Errata

Applies to IP65 step motors from pilot production build

Motors with orange, orange/white, red, red/white, black, black/white, yellow, yellow/white.

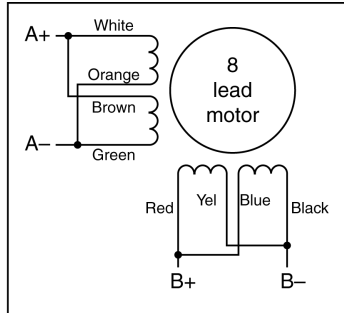
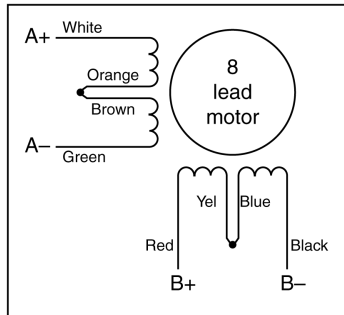
1. Some units have cables that are rated 80°C. These motors should be operated such that the case temperature does not exceed 80°C.
2. The wire colors may differ from our standard. See wiring diagrams below and on the back.

Eight lead motor connected in PARALLEL to a bipolar drive.

Eight lead motor connected in SERIES to a bipolar drive.

Eight lead motor connected to a unipolar drive.
